BASRAH INTERNATIONAL AIRPORT –
AIR SIDE POWER SUPPLY TO
NAVAIDS AND VISAIDS
BASRAH, IRAQ

PROJECT NUMBER SIGIR-PA-06-050

JUNE 30, 2006

SUBJECT: Basrah International Airport – Air Side Power Supply to NAVAIDS and
VISAIDS, Basrah, Iraq (Report Number SIGIR-PA-06-050)

Figure 1: Schematic of electrical distribution system at the Basrah International Airport

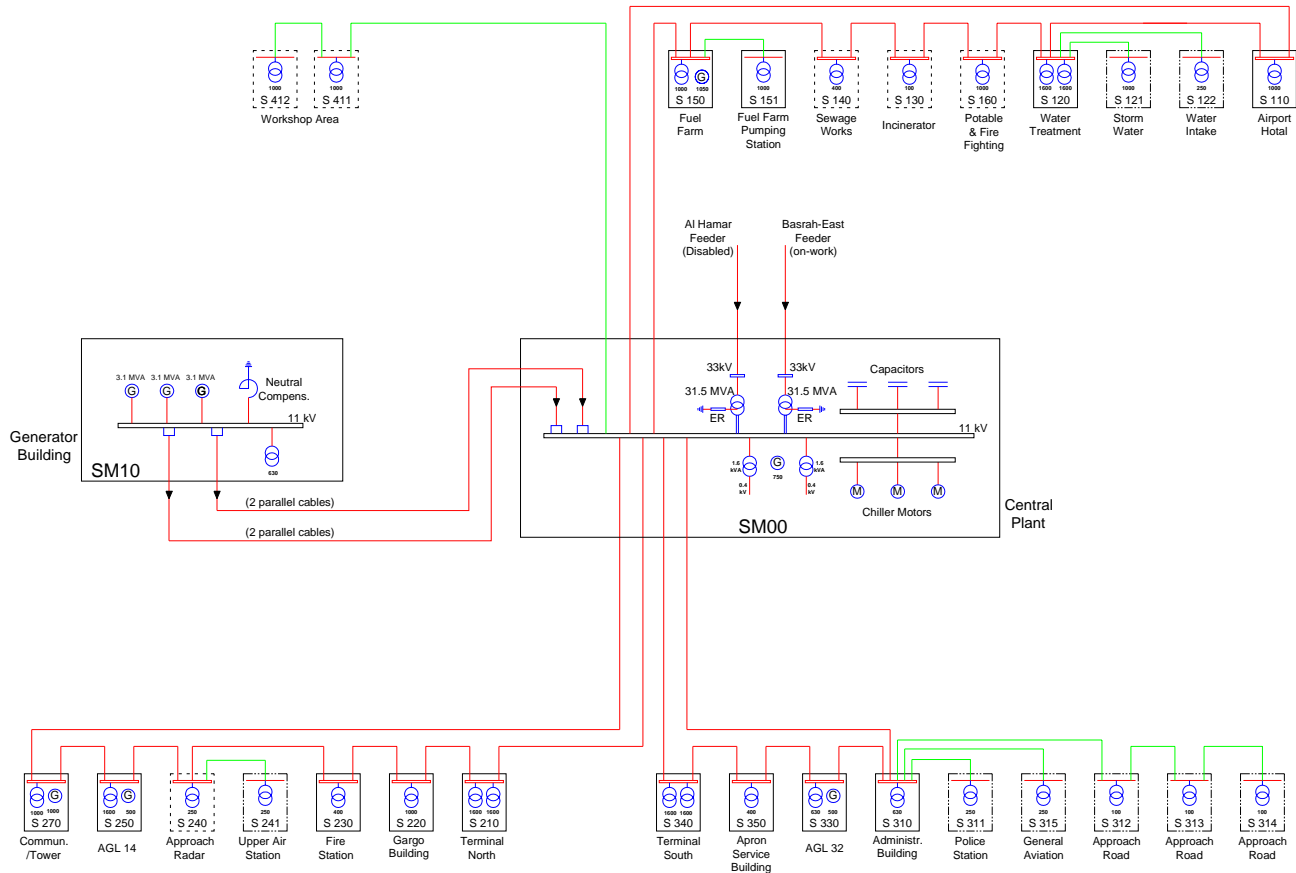
Based on information from the contract files, the BIA electrical system is serviced through two 33 kV (transmission voltage) feeder lines and three on-site generators. The feeder lines transmit power to switchgears and step-down transformers, which convert the electricity from 33 kV to 11 kV. The on-site generators were designed to produce 11kV electricity. The 11 kV electricity, referred to as medium voltage (MV), is distributed through three distribution circuits and are referred to as MV-1, MV-2, and MV-3. The distribution circuits transmit the 11kV electricity to secondary transformers, located at individual facilities within the airport. The secondary transformers convert the voltage from 11kV to 0.4 kV for usage. Figure 1 shows the schematic of the electrical distribution system at the BIA.

Figure 2: Excerpt from PDR schematic showing details of the electrical distribution system at the Basrah International Airport

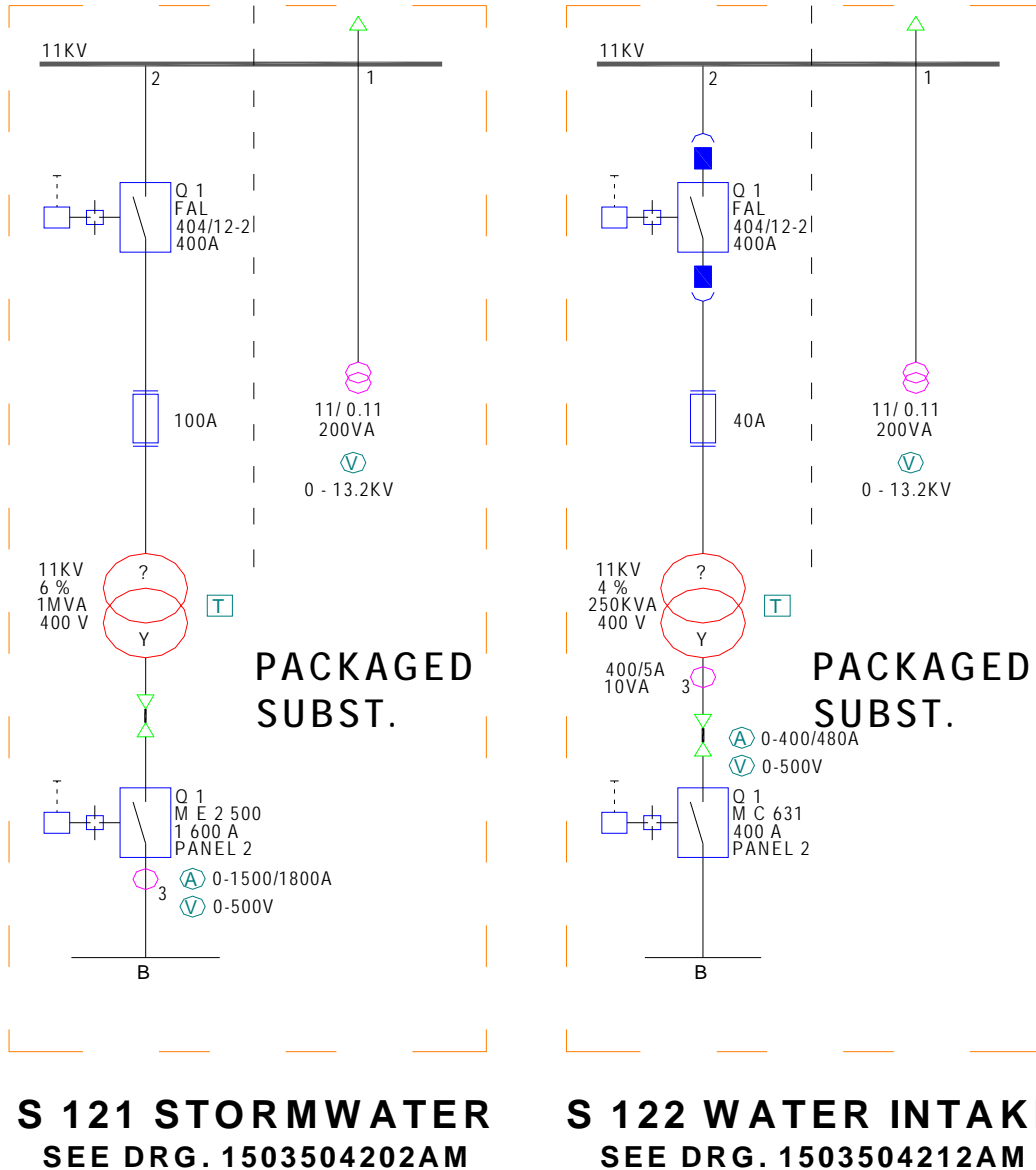
The electrical schematic diagram included the complete BIA MV system with the three MV rings and individual substations. Specific details for the quantity and type of components were included within the schematic. Figure 2 shows an example of a portion of the schematic, which included electrical system details for two of the substations.

The review of the interim PDR, draft PDR, and final PDR showed the submitted reports are consistent with the contract requirements. Although specific scopes of work were not included in the final submittal, the data and schematics should be detailed and specific enough to guide future contracting actions.
